J3u Measurement for CL162

Alexander Rysin and Piers Dawe, NVIDIA

- J3u measurements at TP2 are highly dependent on effects of slew rate and noise and do not reflect actual uncorrelated jitter.
- Current J3u limit is marginal even for test equipment.
- Similar issue was reported in calvin_3ck_adhoc_01_092221 for longer test channels. We observe the J3u marginality for a combination of COM package with recommended TP0-TP2 PCB loss.
- Relates to comments 156 and 171 against D3.0.

Test setup 1

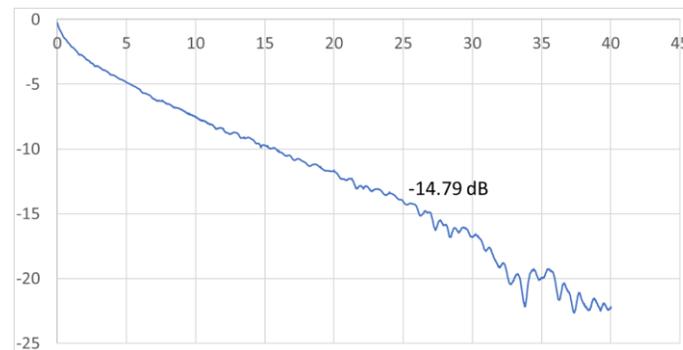
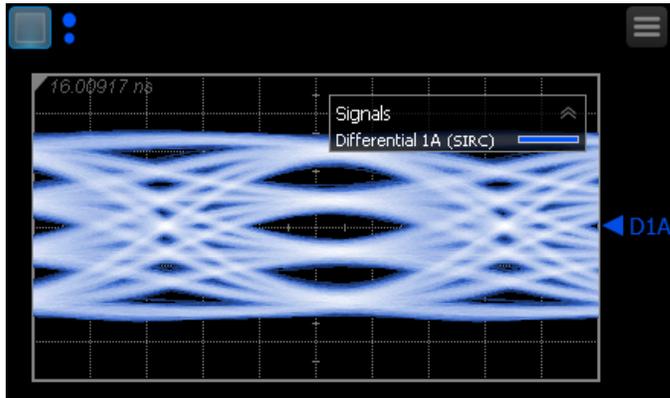
Signal amplitude: 800 mV
J3u: 71.5 mUI
Jrms: 11.1 mUI

PCB trace + OSFP connector + HCB

Total IL – 14.8dB @26.56 GHz
(3.9 dB for COM package +
10.975 dB for recommended loss
between TP0 and TP2)

Test setup 2

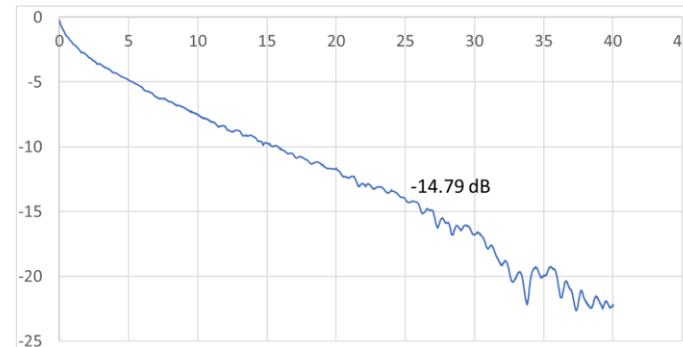
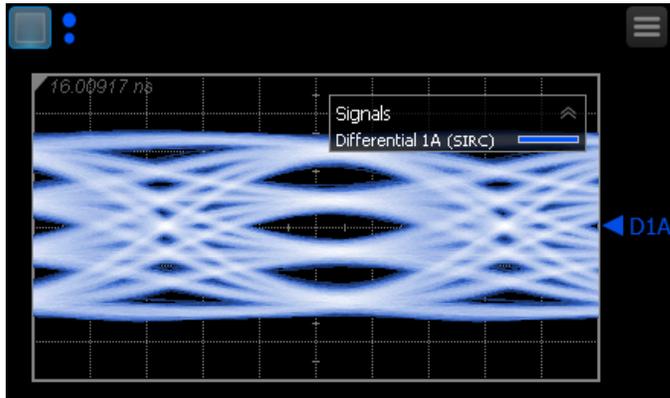
Signal amplitude: 800 mV
J3u: 71.5 mUI
Jrms: 11.1 mUI

Mathematically embedded channel:
PCB trace + OSFP connector + HCB

Total IL – 14.8dB @26.56 GHz
(3.9 dB for COM package + 10.975 dB for recommended
loss between TP0 and TP2)

Dependency on the Transition amplitude

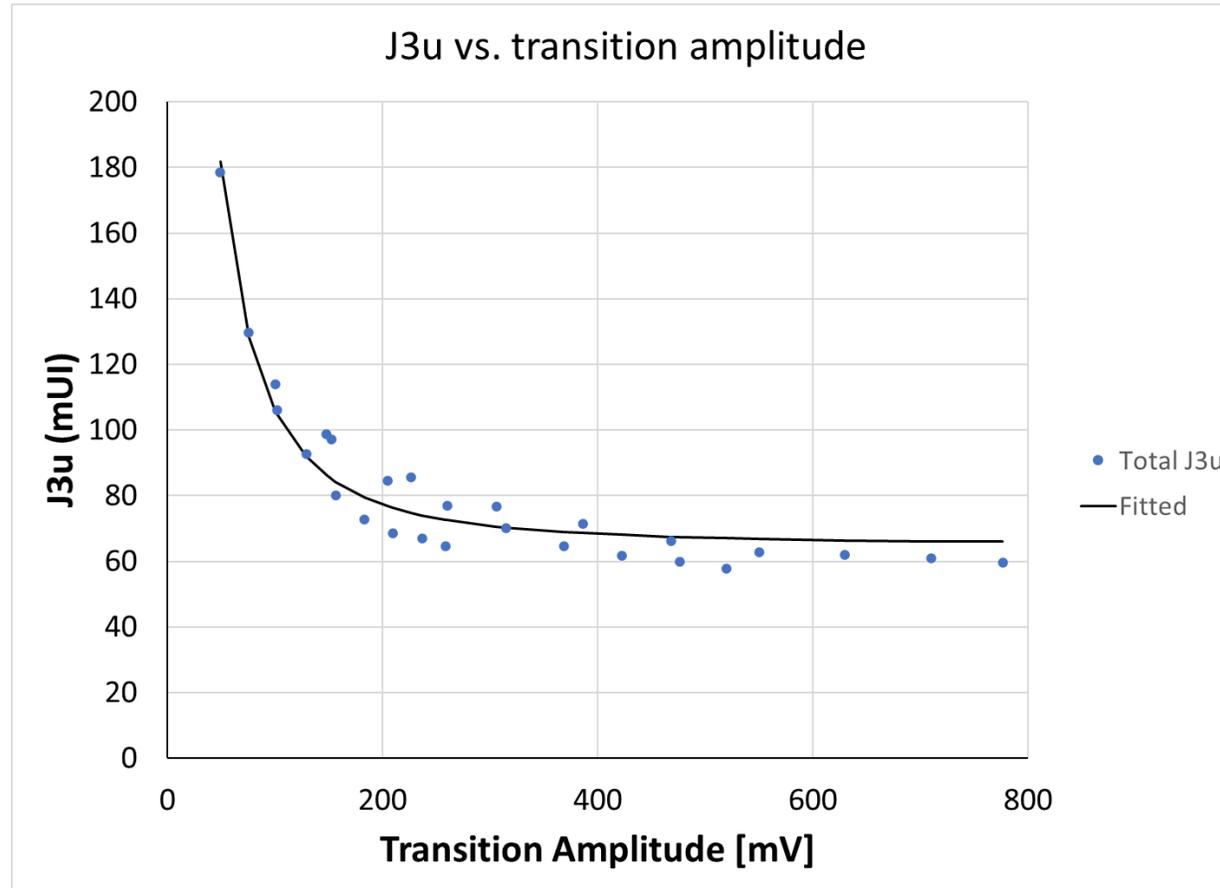
Signal amplitude	Transition	Transition amplitude	J3u
200 mV	2 levels	100 mV	110 mUI
400 mV	1 level	102 mV	106 mUI
200 mV	3 levels	148 mV	98 mUI
300 mV	2 levels	152 mV	97 mUI
600 mV	1 level	156 mV	93 mUI
300 mV	3 levels	225 mV	85 mUI
400 mV	2 levels	205 mV	84 mUI
500 mV	2 levels	260 mV	69 mUI
1000 mV	1 level	259 mV	65 mUI

$$Fitted J3u[mUI] = \sqrt{65.07^2 + \left(\frac{8366.6}{TA[mV]}\right)^2}$$

- Higher limit for J3u to encounter for the measurement issues:
 - In CL 162 Table 162-9 change J3u from 115 mUI to 125 mUI
- Alternatively, apply fitting formula to compensate for the measurement impairments.
